## 4 Masterplan & Public Realm

# 6 Comparison Drawings

The following pages contain a series of comparison drawings to allow the amended design changes to be reviewed directly alongside the original approved planning drawings.

6.2.5 Second Floor Plan

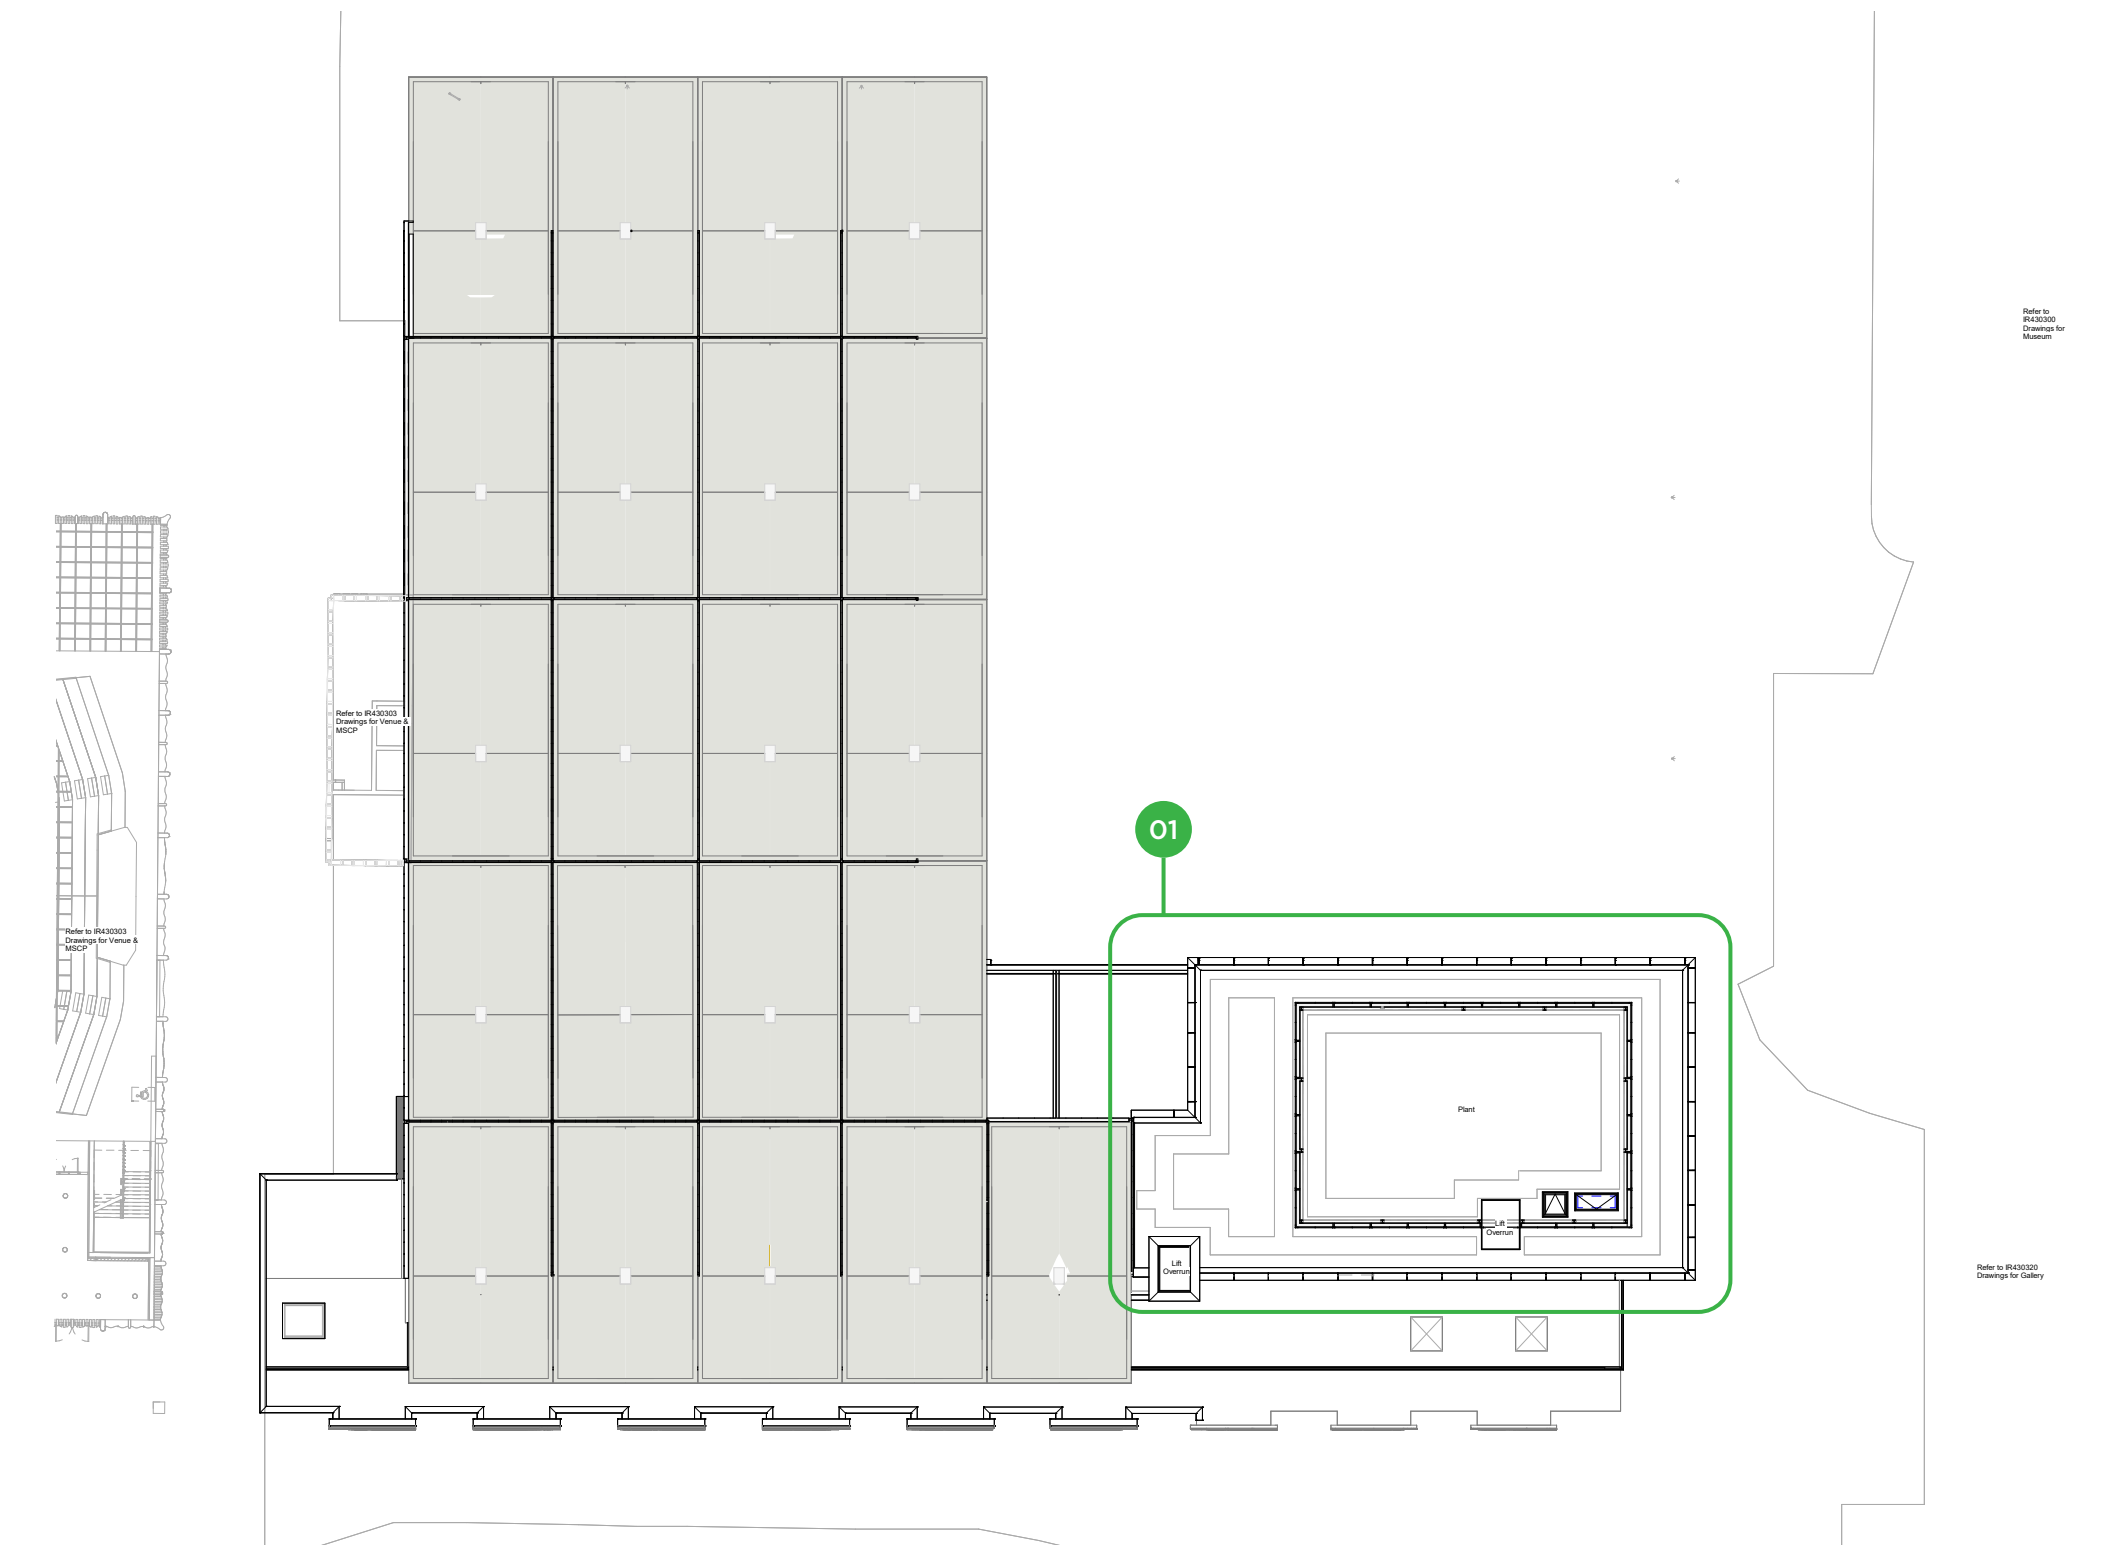
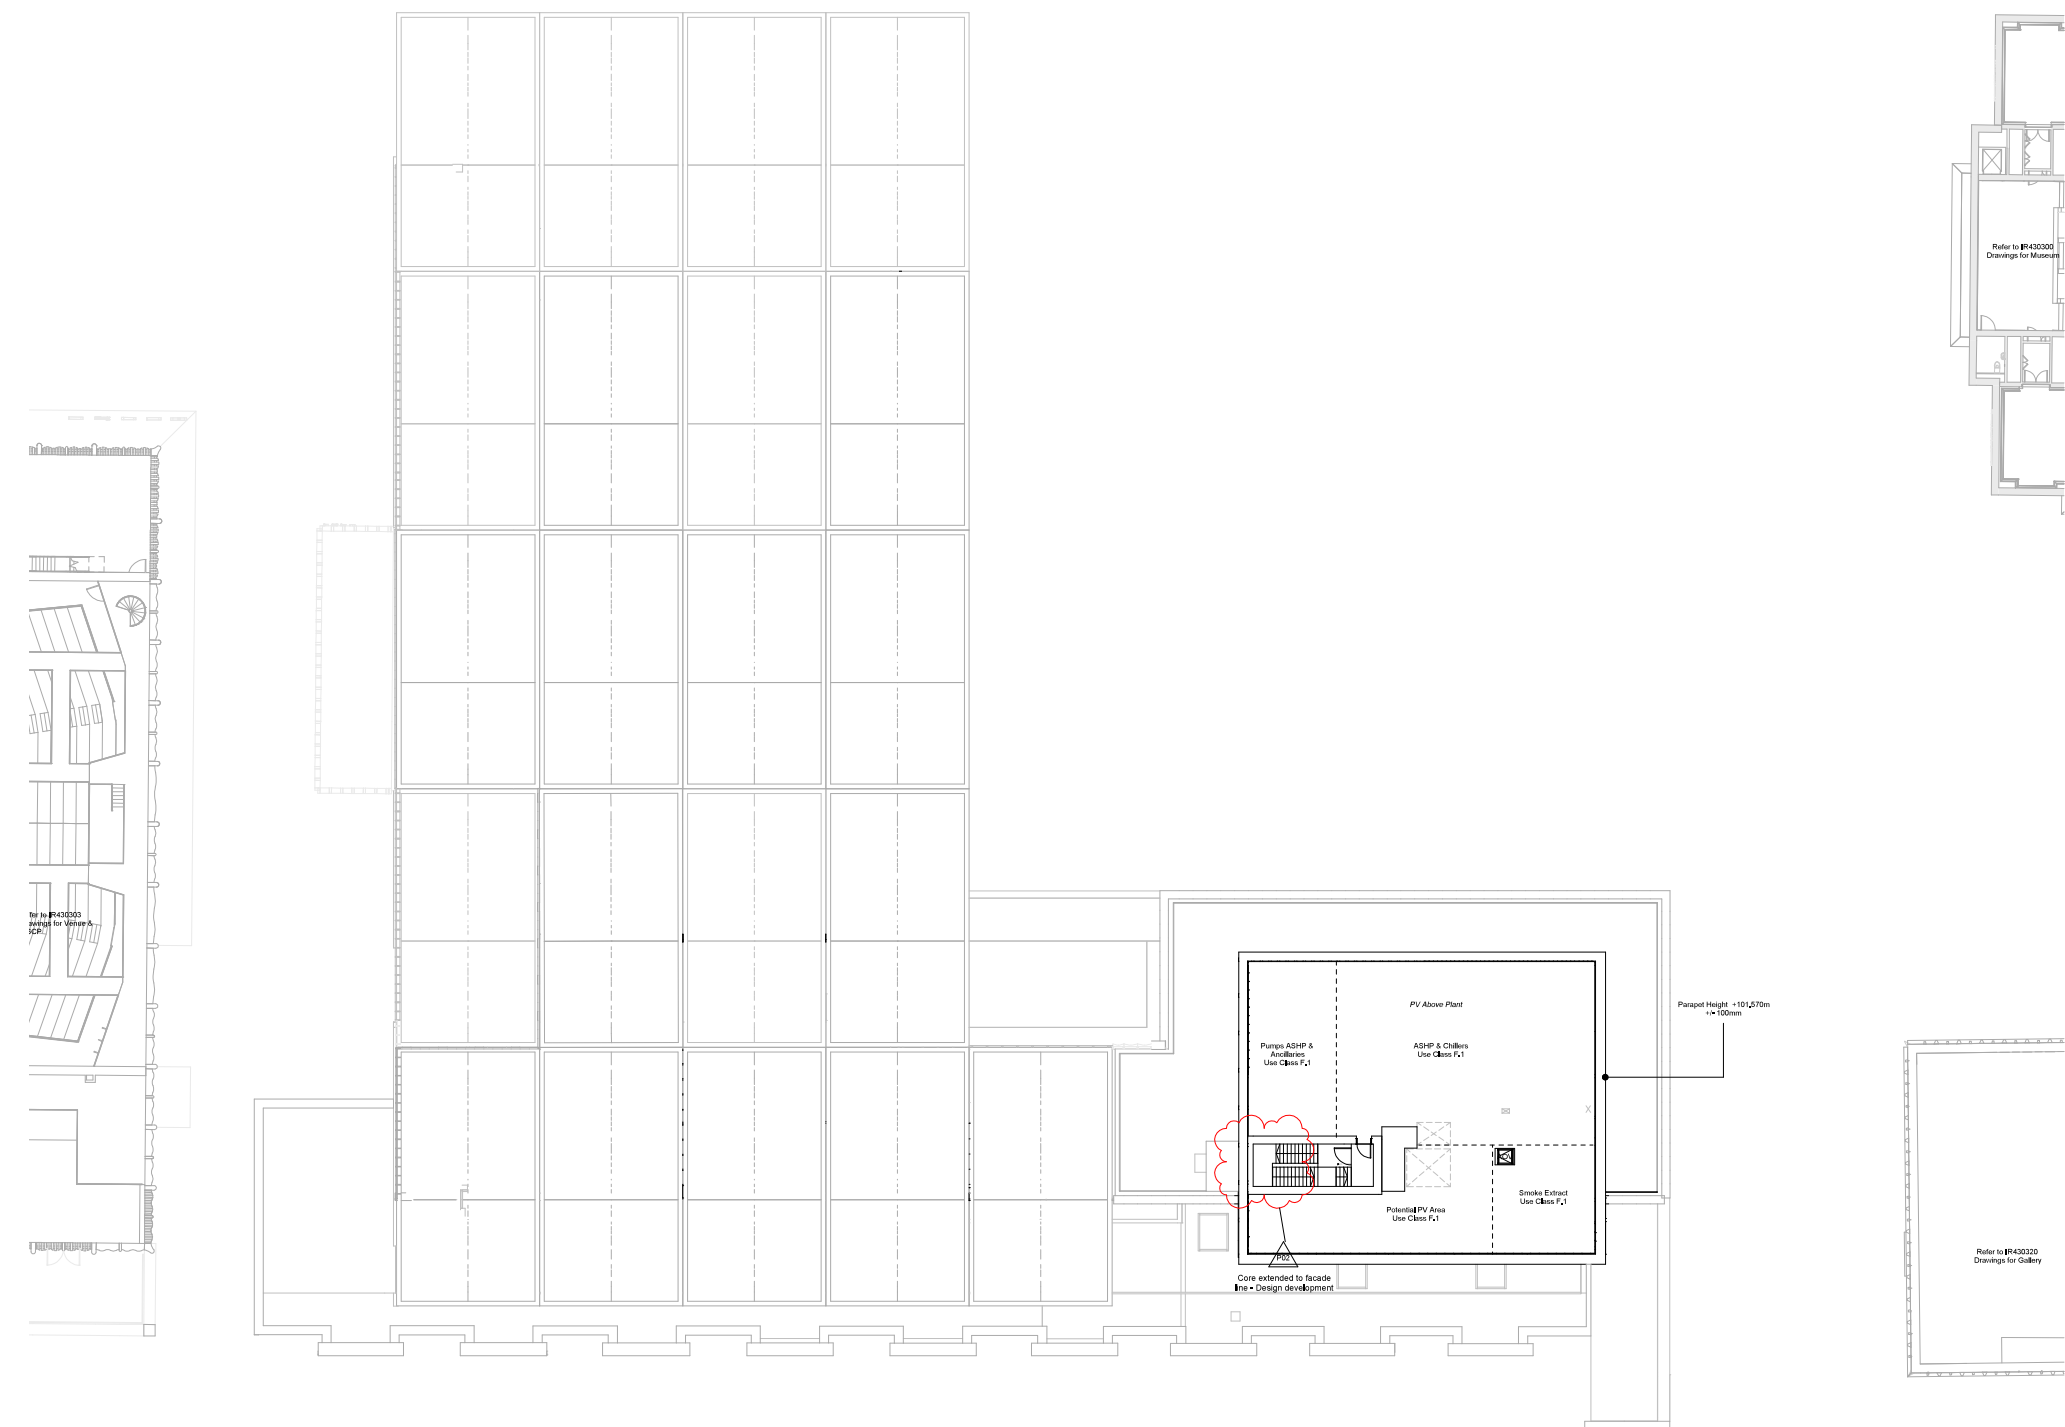
- 01 Omission of accommodation at second floor (event space and multi-purpose room) and relocation of plant enclosure down to this level.

6.2.6 Roof Plan

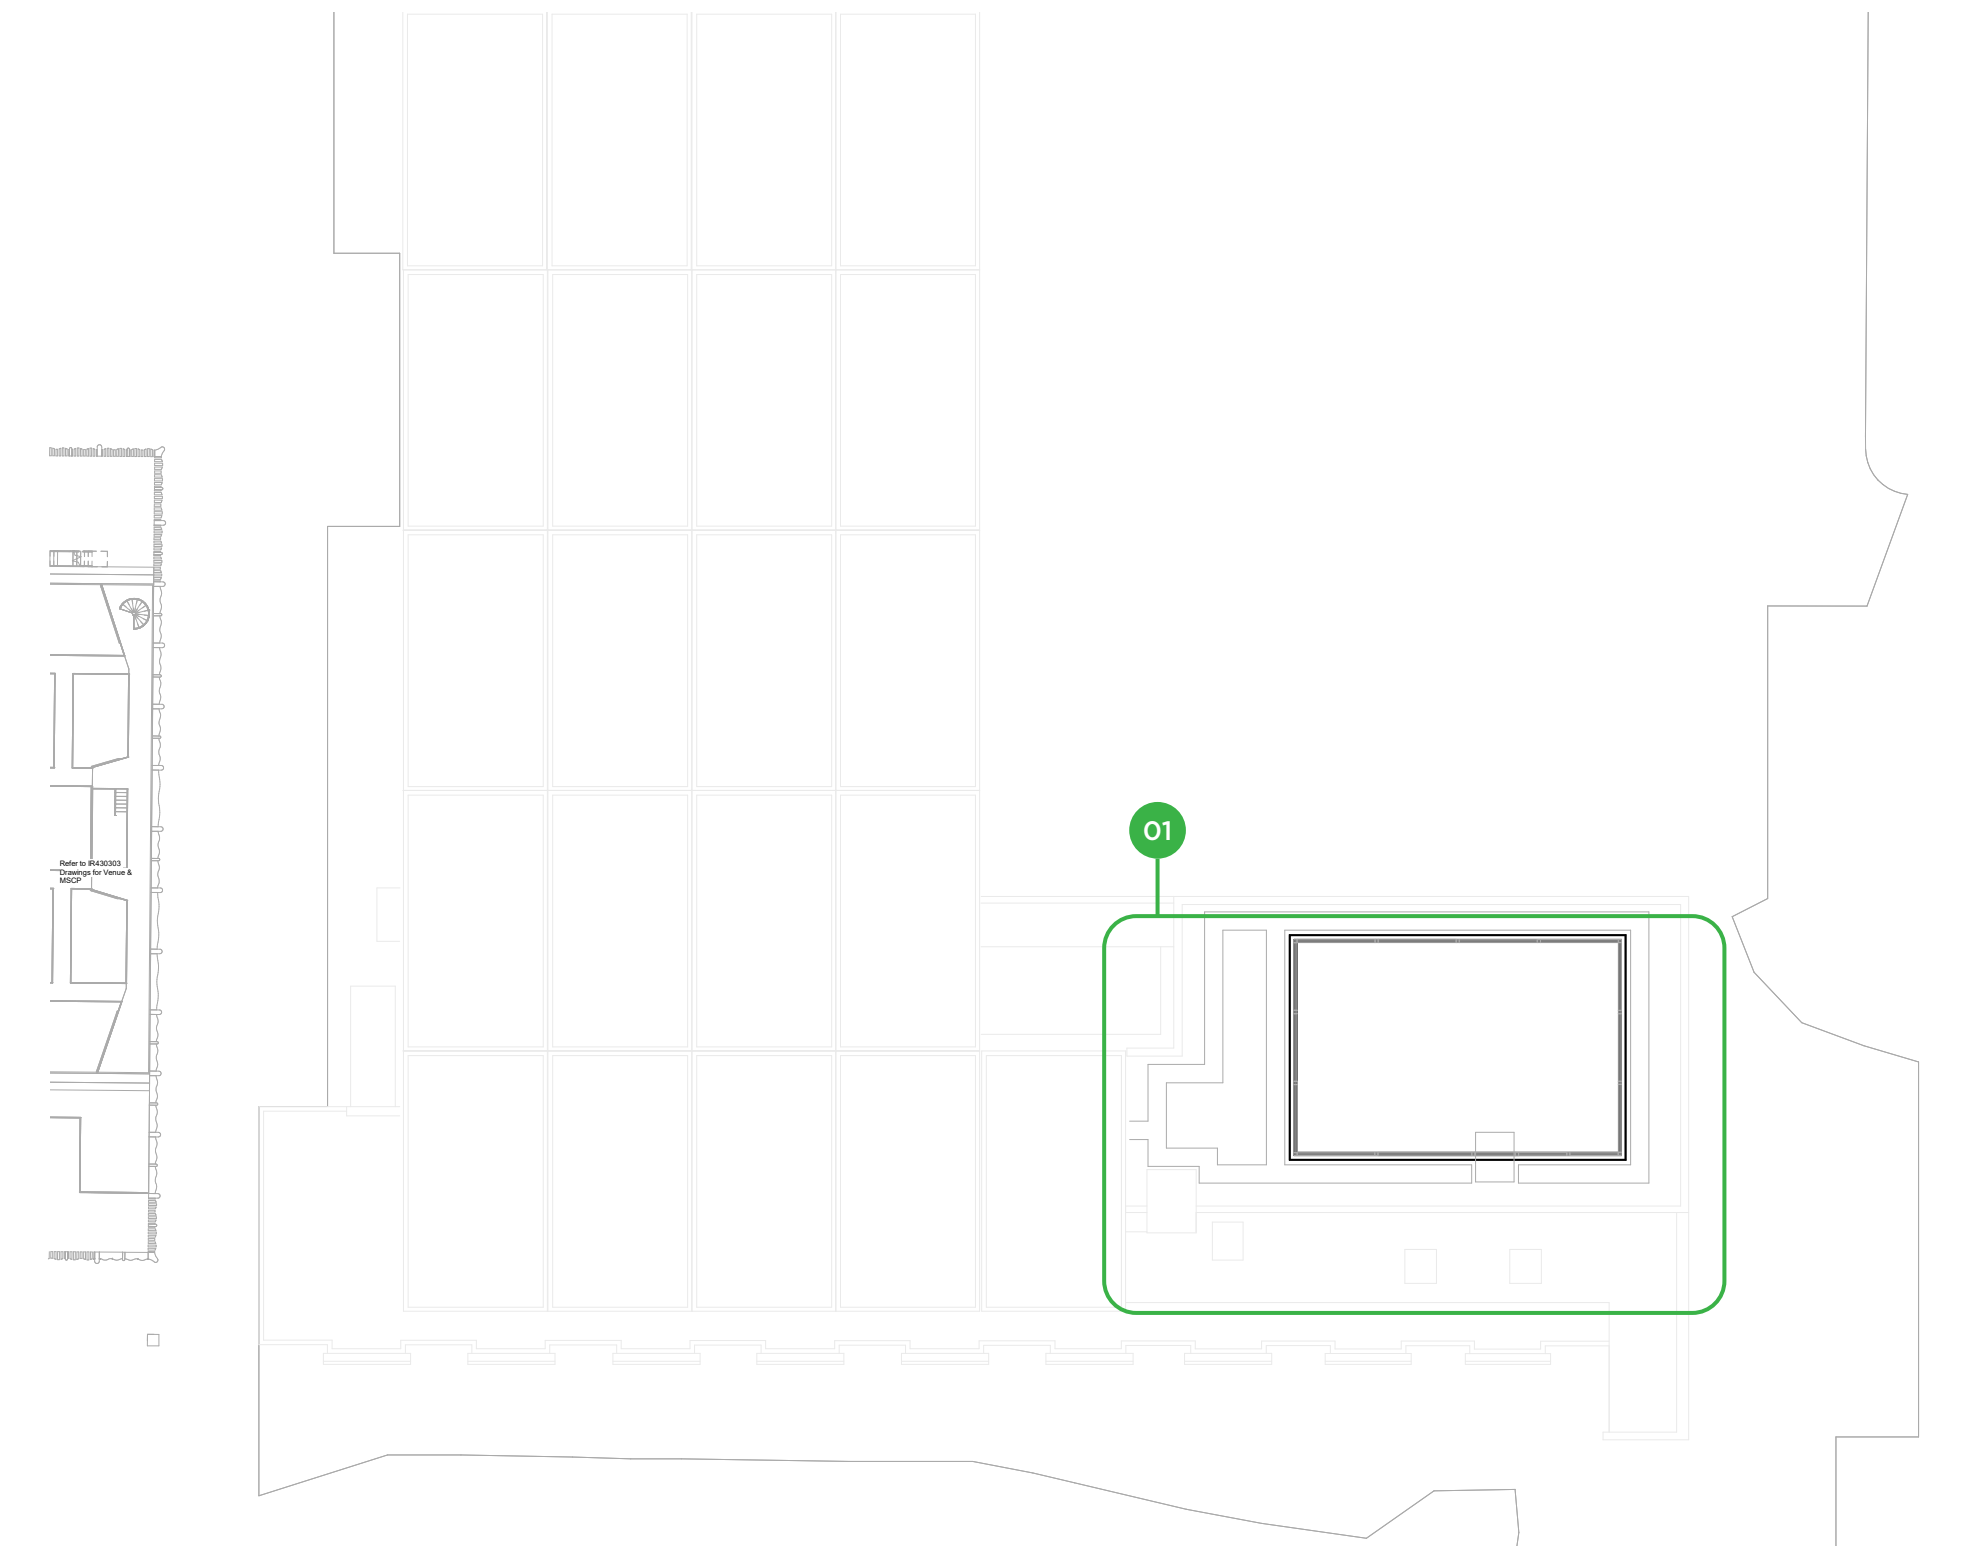
- 01 Plant enclosure relocated to Level 2.
